Delegated Report

Householder Planning Application

Planning Application No: 20220943

Location: 245 Singlewell Road Gravesend Kent DA11 7RN

ELEVATION
100

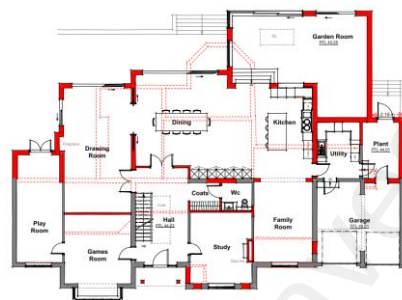
To the right hand side there will be a minor alteration to the brickwork finish at first floor level which will be replaced with white render. There will also be the installation of ground source heat pumps. The proposal also shows the introduction of a window serving a utility room at ground floor level in the flank elevation.

The right hand elevation the proposal will now remain largely the same with the exception of the introduction of a window at ground floor level which will serve a utility room and air source heat pumps. The original submission showed a 2.2m increase in the rear projection of the garage which then had a cumulative effect on the vastness of the flat roof, however after discussions with the agent the plans were revised to omit this projection.

Approved First Floor Plans under 20211348

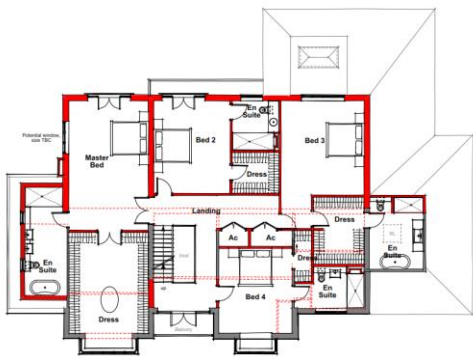
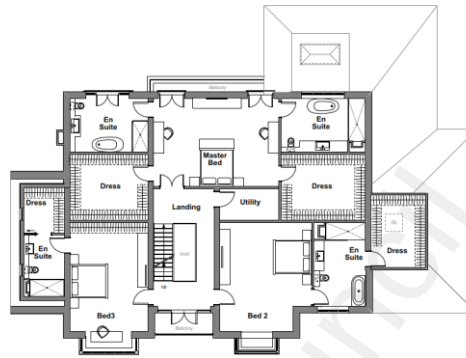
At first floor the proposal will see the introduction of a balcony to the rear and additional Juliet balconies and changes to the fenestration.

The revised proposal will also see the introduction of a balcony at first floor level. Given that No.245 is set behind No 247 it is not liable to result in any harm in terms of overlooking or privacy especially considering there are trees which offer a form of screening. The balcony will not be able to see into the garden of No.245a as the roof of the single storey rear extension will block the view.

Approved Second Floor Plans under 20211348

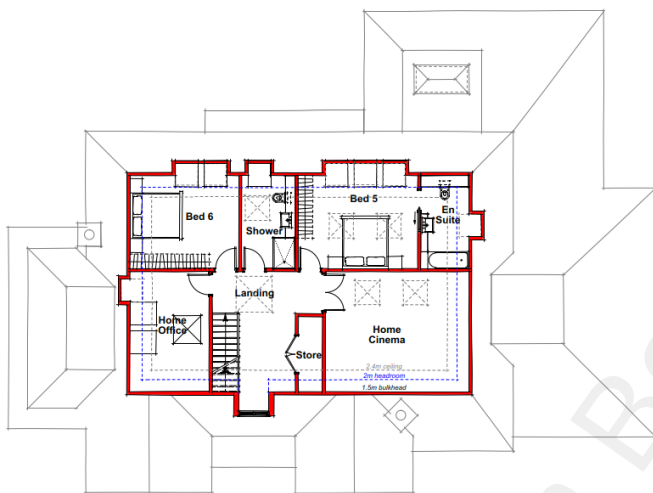
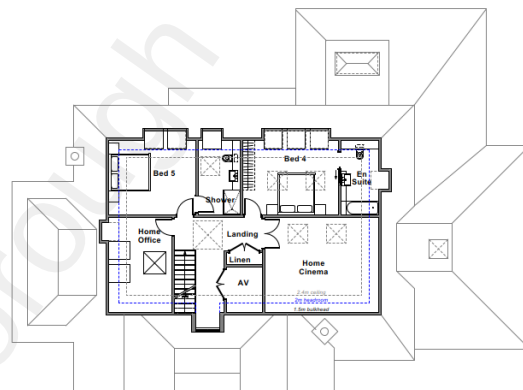
At second floor the alterations are more or less the same.
